**FAX Transmission**

To: DARREN MARSH From: PAT LUJAN  
 Fax: 650-926-4979 Pages: 4 TOTAL  
 Phone: \_\_\_\_\_ Date: 11.1.04  
 Re: NCMR 2037 cc: BRIGITE ESTEY

# GENERAL TECHNOLOGY CORPORATION NONCONFORMANCE MATERIAL/RMA REPORT

<b>NCMR NUMBER</b>	2037	<b>CUSTOMER RETURN</b>
<b>DATE</b>	10/11/2004	<b>RMA NUMBER</b>
<b>CUSTOMER</b>	SLAC	<b>QUANTITY RETURNED</b>
<b>CUSTOMER</b>	PAT LUJAN	<b>VENDOR DEFECT</b>
<b>VENDOR</b>	General Technology	<b>QUANTITY REJECTED</b> 3
<b>PART NUMBER</b>	LAT-DS-01646	<b>PRODUCTION</b>
<b>LOT QUANTITY</b>	3	<b>QUANTITY REJECTED</b>
<b>SALES ORDER</b>	F17200	<b>REWORK</b>
<b>PURCHASE ORDER</b>	48799	<b>QUANTITY</b>
<b>LOT NUMBER</b>		<b>PURCHASING DEFECT</b>
<b>WORK ORDER</b>	110154, 110155, 110156	<b>PURCHASING QUANTITY REJECTED</b> 3
<b>INITIATOR</b>	P. LUJAN	
<b>ASSIGNED TO</b>	PAT LUJAN	
<b>DATE REQUIRED</b>	10/11/2004	
<b>ASSIGNED TO</b>		
<b>DISCREPANCY</b>	SN's "1, 2 and 3" (Currently not identified as with SLAC numbers)

## REWORK TRAVELER

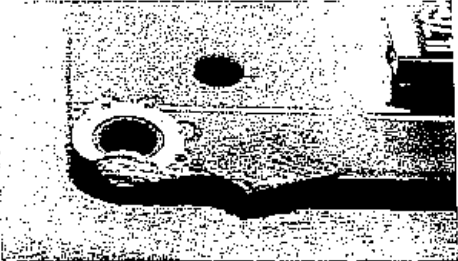
**Finding:** Customer finding - SN 1, 2 & 3  
PWA dropped from an approximate distance of 36". PWB sustained damage (dings) along edges of board. Photographs were e-mailed to SLAC for evaluation.

STEP	OPERATION	Operator Sign Off.	Date	Time spent
	<p><i>THIS REWORK TRAVELER APPLIES COATING MATERIAL TO LOCATIONS ON CORNERS OF CCAS DAMAGED BY FALLING OFF A STORAGE TRAY. REWORK AUTHORIZED VIA EMAIL FROM B. ESTEY, DATED 12/12/04; 4:21 pm (ATTACHED)</i></p>			
REF	<p>PICTURES OF DAMAGE TO SN #2 (614)...</p> <div style="display: flex; justify-content: space-around;">   </div> <div style="display: flex; justify-content: space-around; margin-top: 10px;">   </div> <p>NOTE DEFORMED CORNER PADS.</p>			
REF cont.	<p>PICTURES OF DAMAGE TO SN #3 (612)...</p> <div style="display: flex; justify-content: space-around;">   </div> <div style="display: flex; justify-content: space-around; margin-top: 10px;">   </div> <p>NOTE DEFORMED CORNER PADS.</p>

STEP	OPERATION	Operator Sign Off.	Date	Time spent
	<i>THIS REWORK TRAVELER APPLIES COATING MATERIAL TO LOCATIONS ON CORNERS OF CCAS DAMAGED BY FALLING OFF A STORAGE TRAY. REWORK AUTHORIZED VIA EMAIL FROM B. ESTEY, DATED 12/12/04; 4:21 pm (ATTACHED)</i>			
1	Serial numbers: #2 (614), #3 (612) REFERENCE NCMR # 2082 AND # 2083.			
2	TOOLS AND MATERIALS: <b>MIXING CONTAINER - PLASTIC, METAL, OR GLASS</b> <b>MIXING UTENSIL - PLASTIC, METAL, OR GLASS</b> <b>SCALE - GRAM, CALIBRATED</b> <b>PLIERS – METAL, NEEDLE, SMOOTH JAW SURFACE</b>			
3	<p>MIX A SMALL AMOUNT OF THE TWO PARTS OF COATING MATERIAL, ARATHANE-5750, FOR BRUSH APPLICATION TO DAMAGED LOCATIONS ON EACH CCA. REFER TO PICTURES ON FOLLOWING PAGE. USE THE FOLLOWING RATIO TO MIX THE MATERIAL:</p> <p>PART A      18 PARTS BY WEIGHT    <b>EXAMPLE: (0.54 GRAMS)</b></p> <p>PART B      100 PARTS BY WEIGHT            <b>(3.00 GRAMS)</b></p> <p>MIX SLOWLY, BY HAND, TO MINIMIZE AIR ENTRAPMENT.</p> <p>POT LIFE IS APPROXIMATELY TWO (2) HOURS).</p> <p>LET MIXED MATERIAL STAND FOR HALF AN HOUR TO RELEASE ANY ENTRAPPED AIR.</p> <p><b>RECORD MIXTURE AMOUNTS, MATERIAL LOT/BATCH CODE, AND EXPIRATION DATE, BELOW:</b></p> <p>AMOUNTS MIXED: PART A: _____ PART B: _____</p> <p>CODE: _____ EXPIRATION DATE: _____</p>

# REWORK TRAVELER

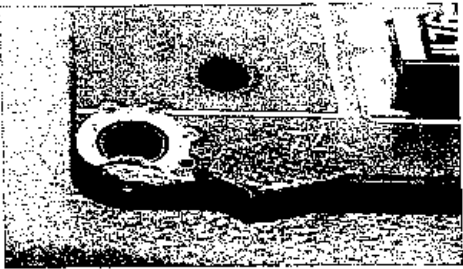
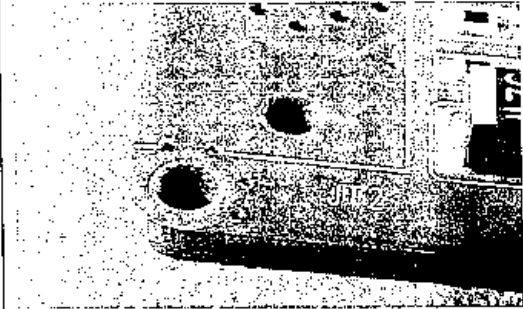
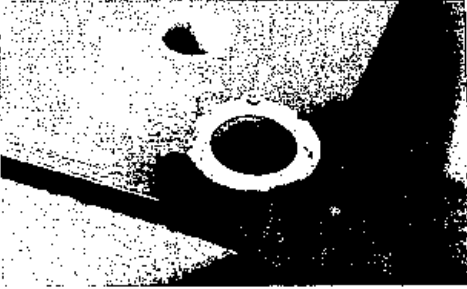
STEP	OPERATION	Operator Sign Off.	Date	Time spent
1	Serial numbers: #2 (614), #3 (612) REFERENCE NCMR # 2082 AND # 2083.			
2	<b>TOOLS AND MATERIALS:</b> ✓ MIXING CONTAINER - PLASTIC, METAL, OR GLASS ✓ MIXING UTENSIL - PLASTIC, METAL, OR GLASS ✓ SCALE - GRAM, CALIBRATED ✓ PLIERS - METAL, NEEDLE, SMOOTH JAW SURFACE			
3	MIX A SMALL AMOUNT OF THE TWO PARTS OF COATING MATERIAL, ARATHANE 5750, FOR BRUSH APPLICATION TO DAMAGED LOCATIONS ON EACH CCA. REFER TO PICTURES ON FOLLOWING PAGE. USE THE FOLLOWING RATIO TO MIX THE MATERIAL:  PART A      18 PARTS BY WEIGHT    EXAMPLE:    (0.54 GRAMS) PART B      100 PARTS BY WEIGHT                      (3.00 GRAMS)  MIX SLOWLY, BY HAND, TO MINIMIZE AIR ENTRAPMENT.  POT LIFE IS APPROXIMATELY TWO (2) HOURS). LET MIXED MATERIAL STAND FOR HALF AN HOUR TO RELEASE ANY ENTRAPPED AIR. RECORD MIXTURE AMOUNTS, MATERIAL LOT/BATCH CODE, AND EXPIRATION DATE, BELOW:  <i>80# 30201</i> AMOUNTS MIXED: PART A: <u>10.0g</u> PART B: <u>1.8g.</u> CODE: <u>AK4GB8013A</u> EXPIRATION DATE: <u>3/05</u> A-code <u>AK4GX8033A</u> Exp-DATE <u>3/05</u>	<i>Mixed</i> <i>DM/1035</i> <i>12-14-04</i>
